SITE PLAN APPLICATION

NAME OF PROPOSED DEVELOPMENT Convenience Store w/Full Serve Gas Station ^{+ DRIVE}
_{THRU CAR WASH}

SITE PLAN REVIEW

Architectural Review Board Site Plan
Comments and Questions

AUTOMOTIVE SERVICE CENTER
 REVISED SCHEMATIC

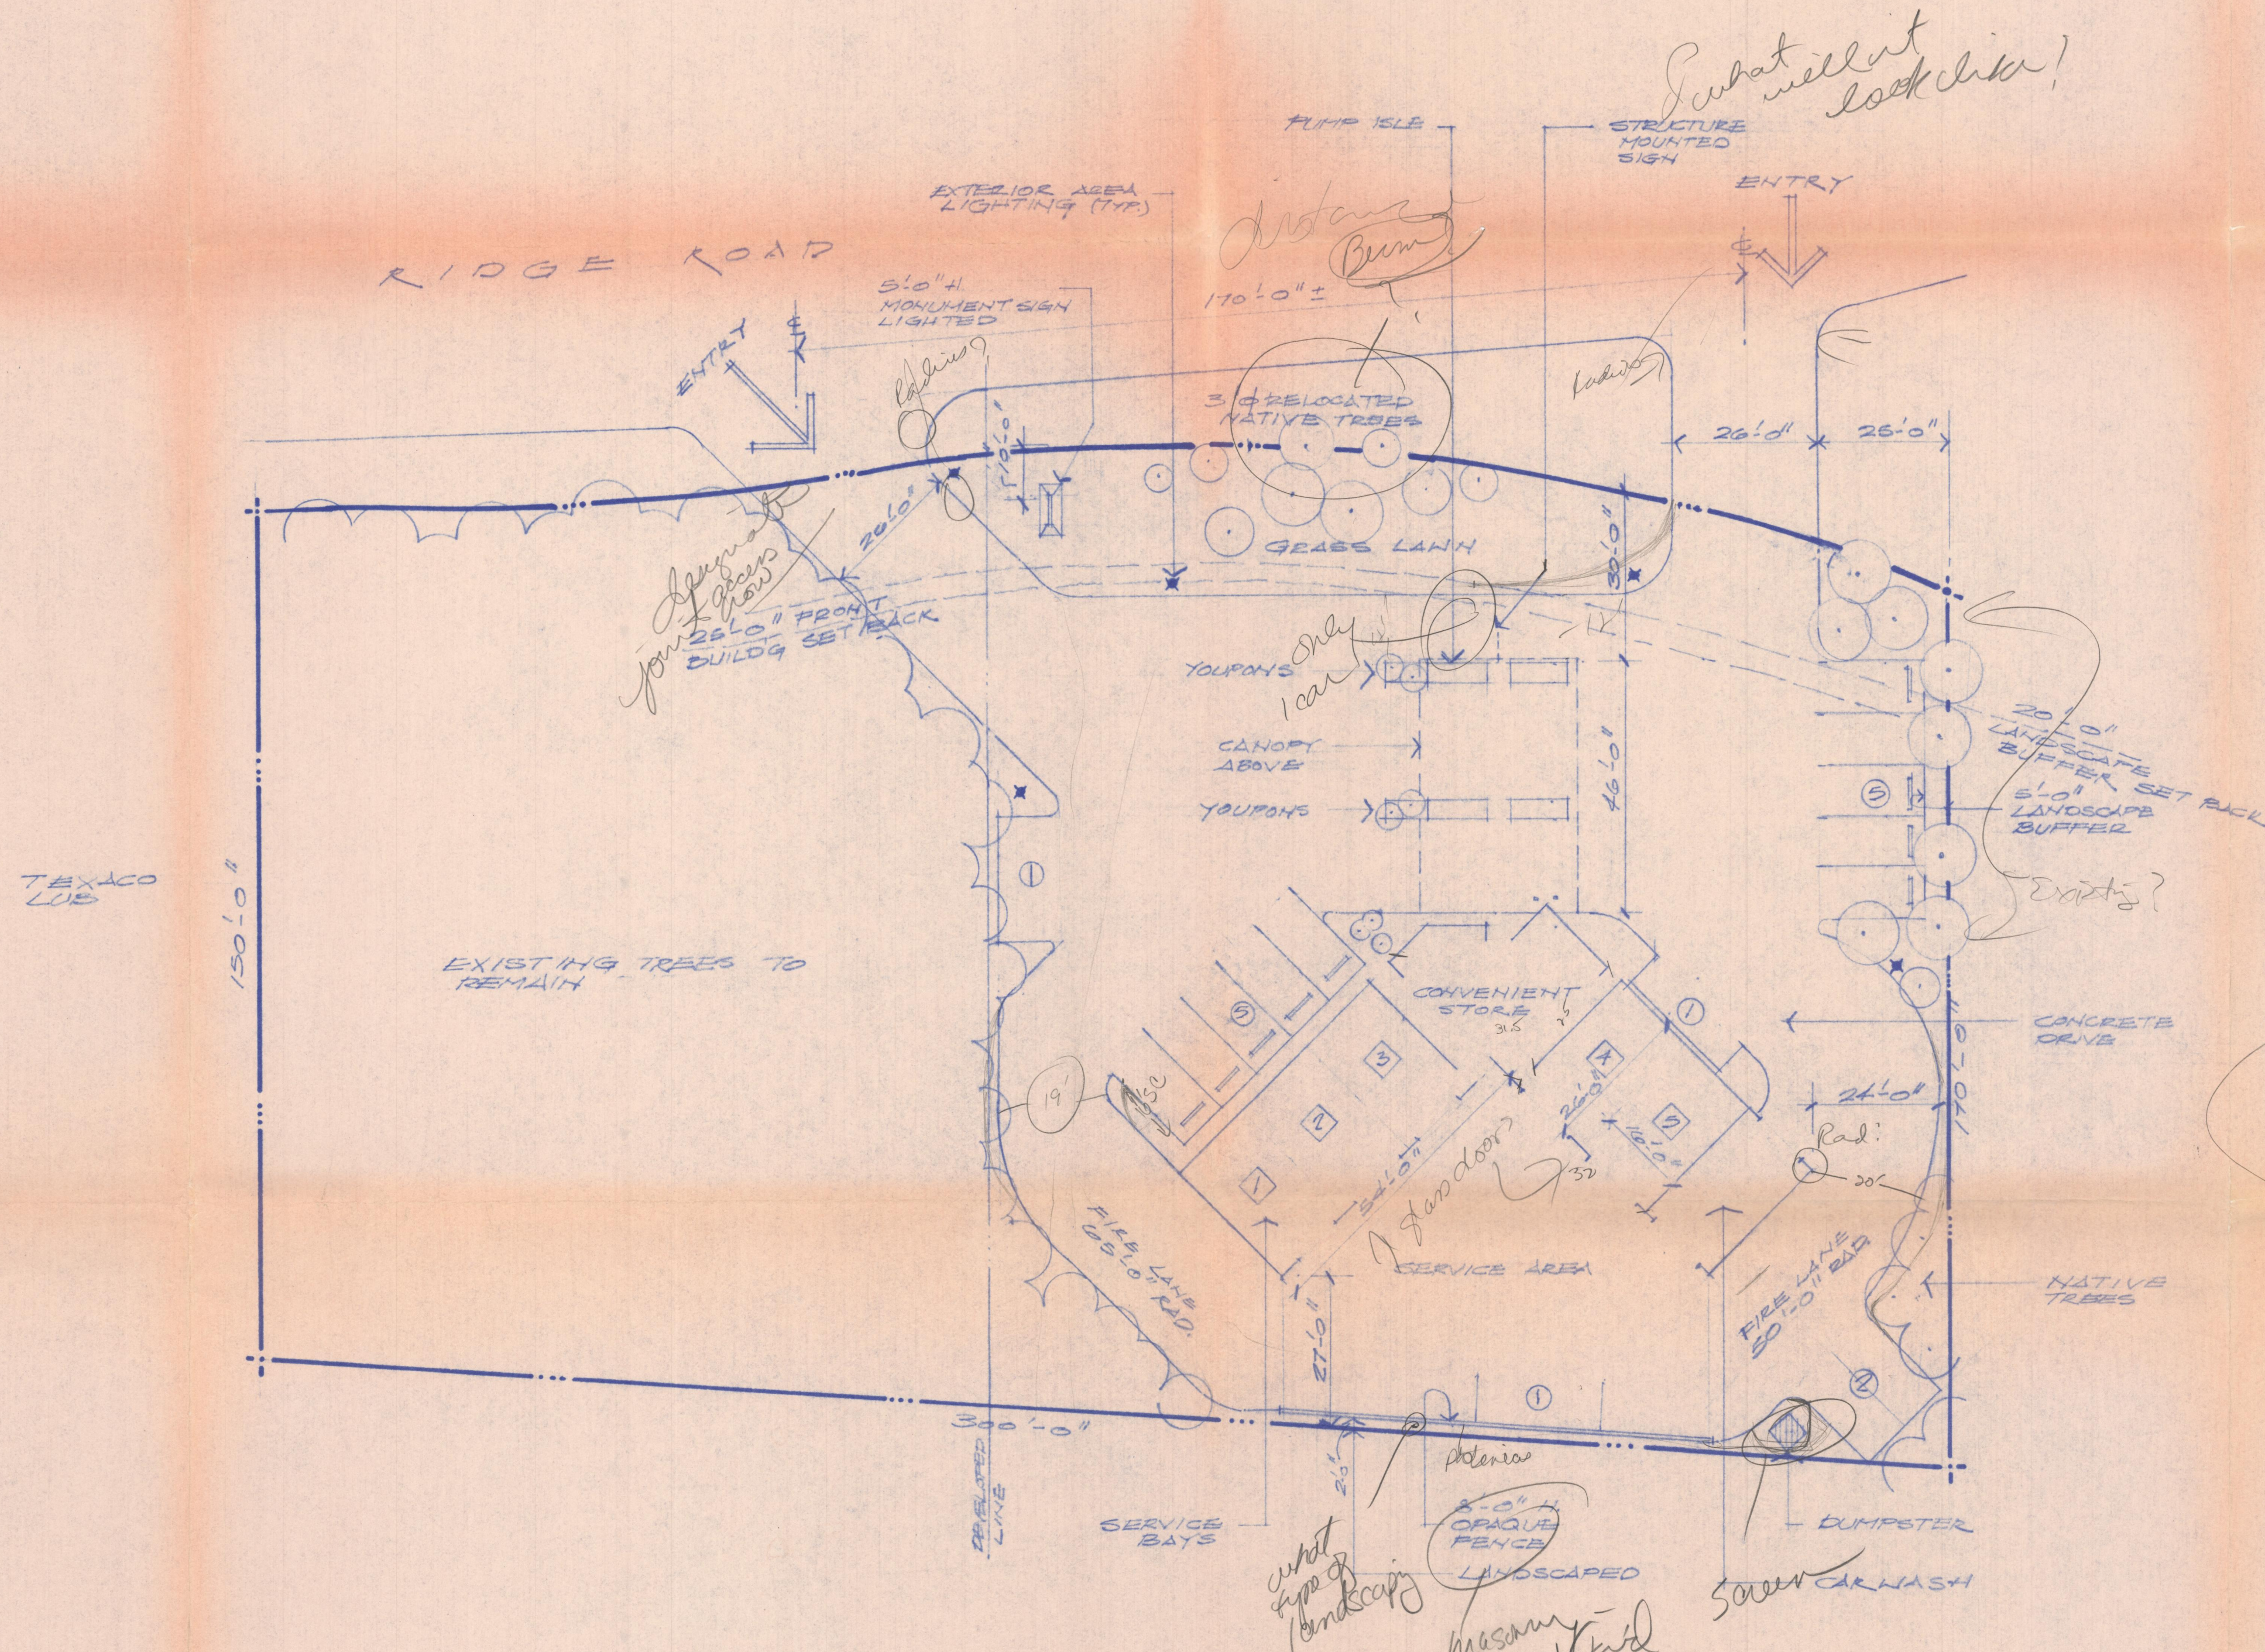
*roof line
 buck wall
 no windows
 mow parking spaces
 sign - mow regional
 topography
 pitched roof
 post modern look*

AUTOMOTIVE SERVICE CENTER REVISED SCHEMATIC site plan

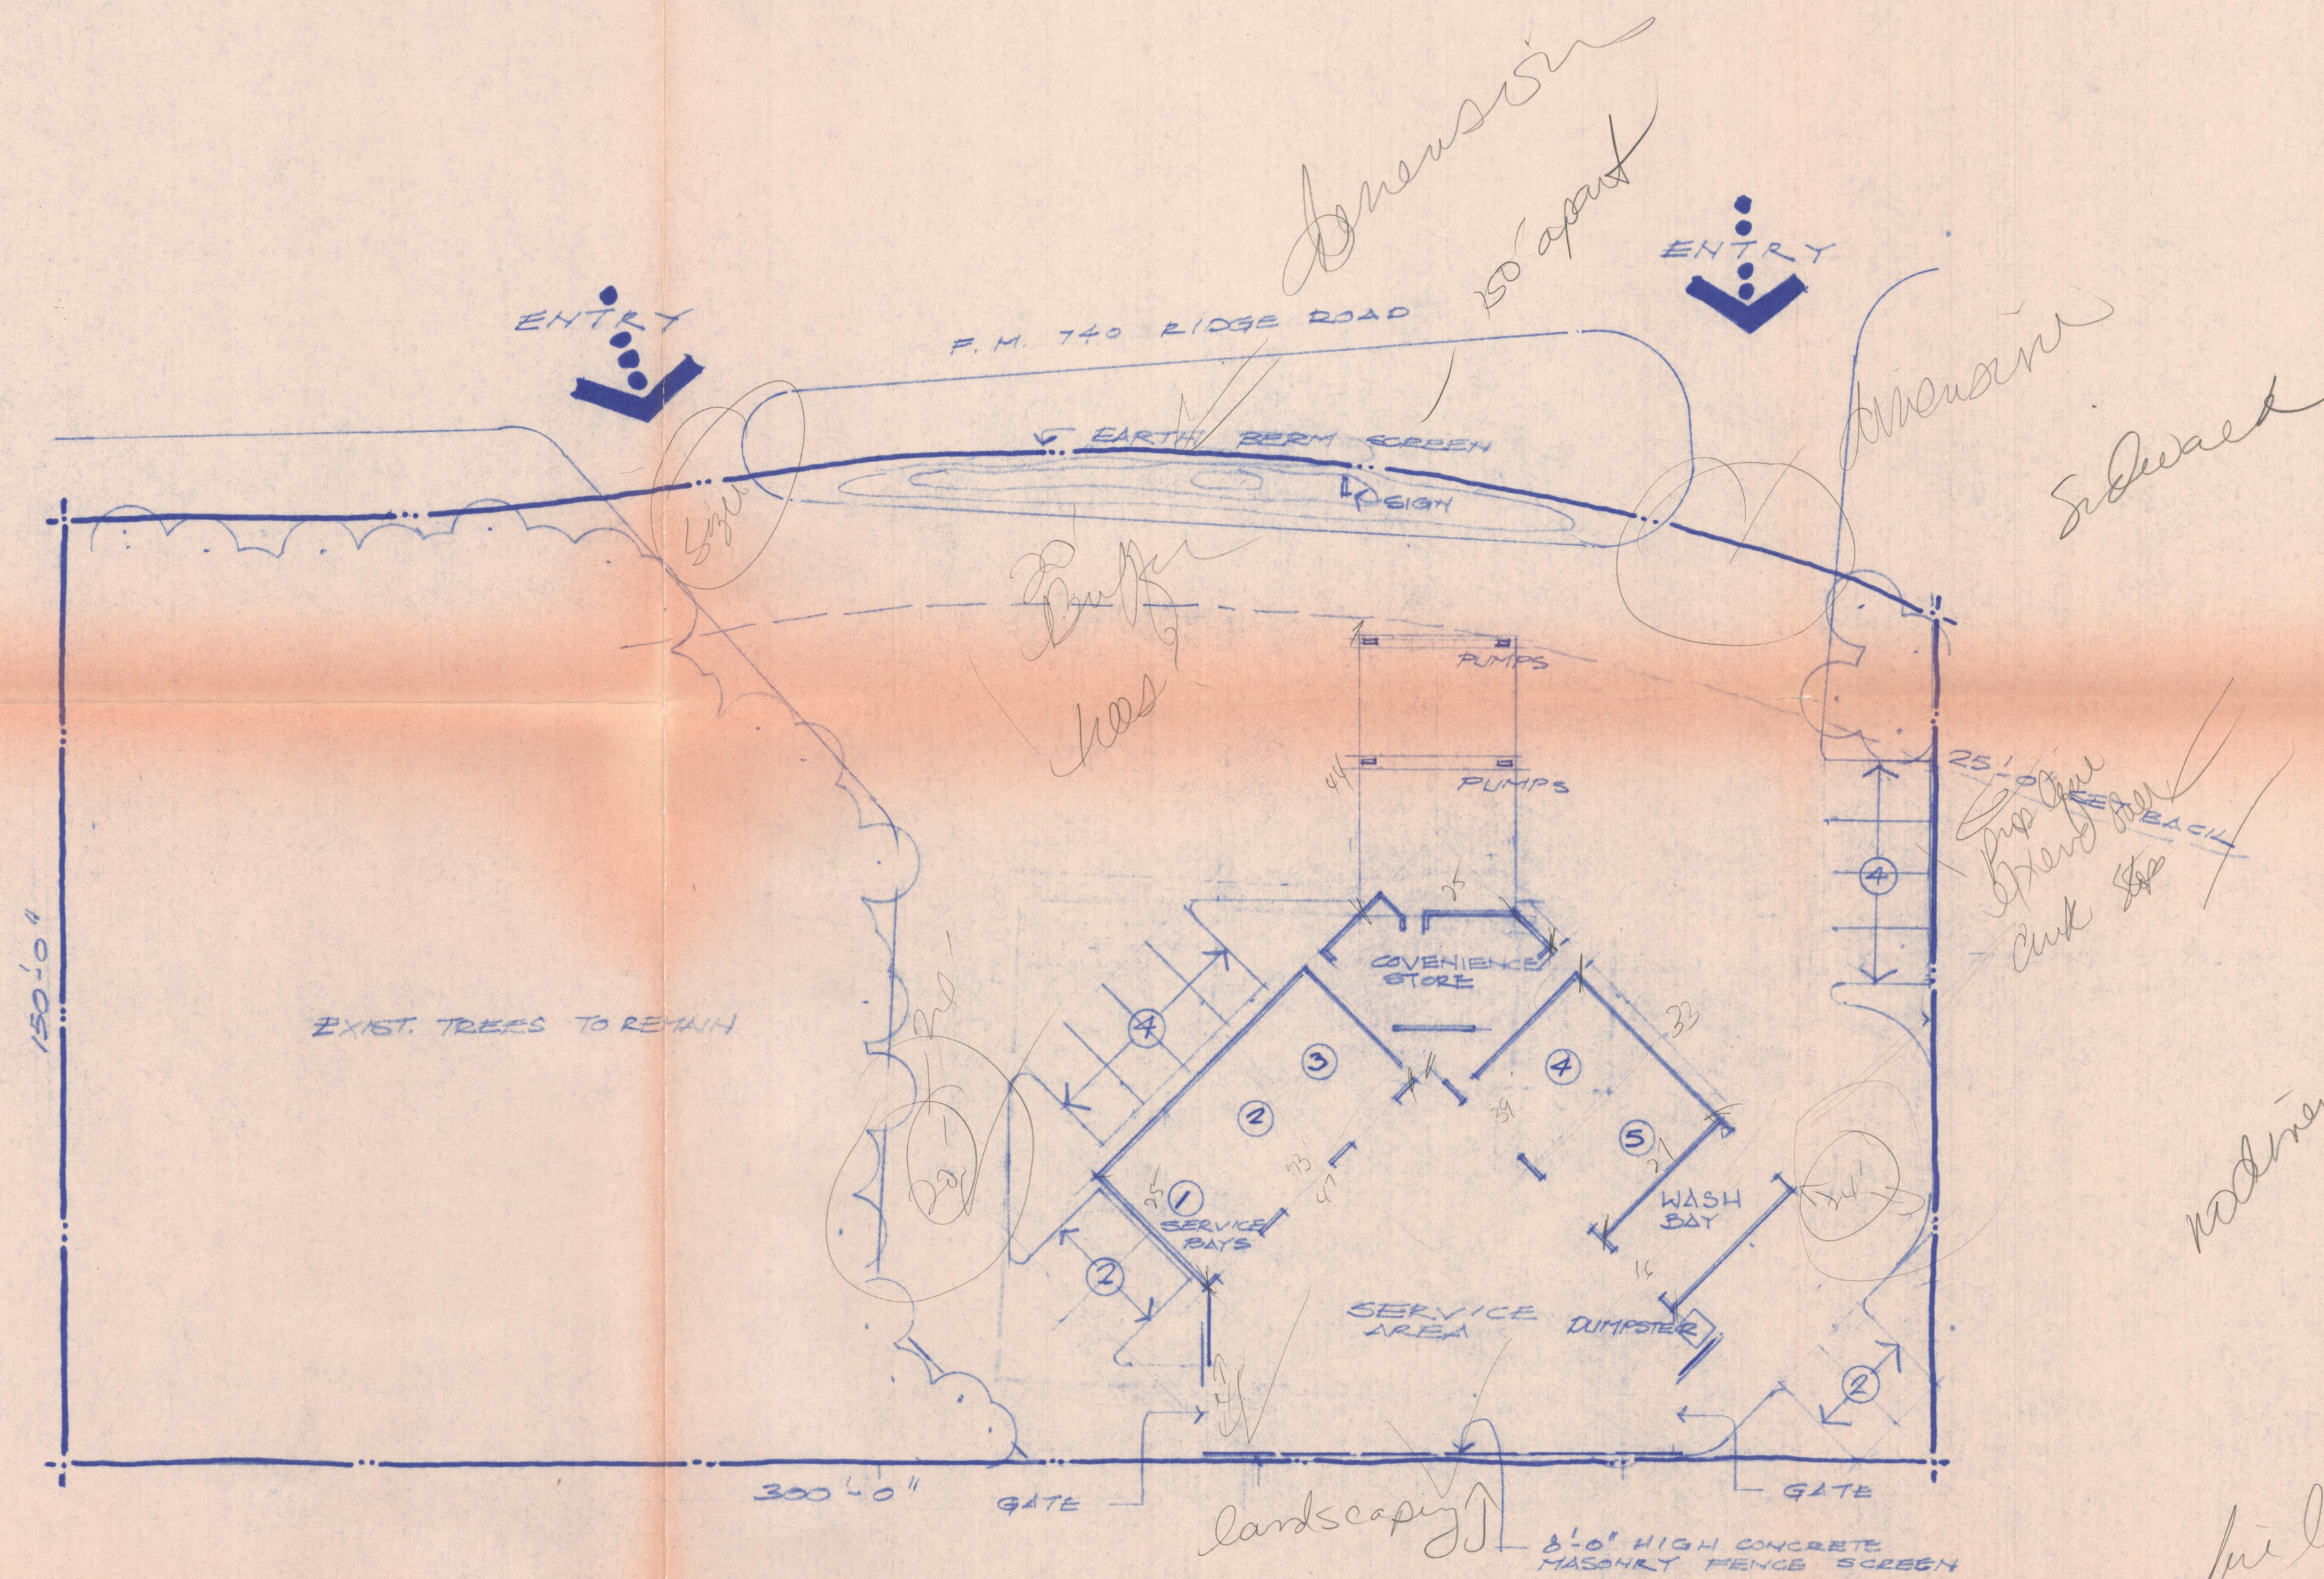
parking?

wall lines to be marked 15 ft radius

what type of landscaping
potenias
opaque fence
landscaped
masonry what will left well
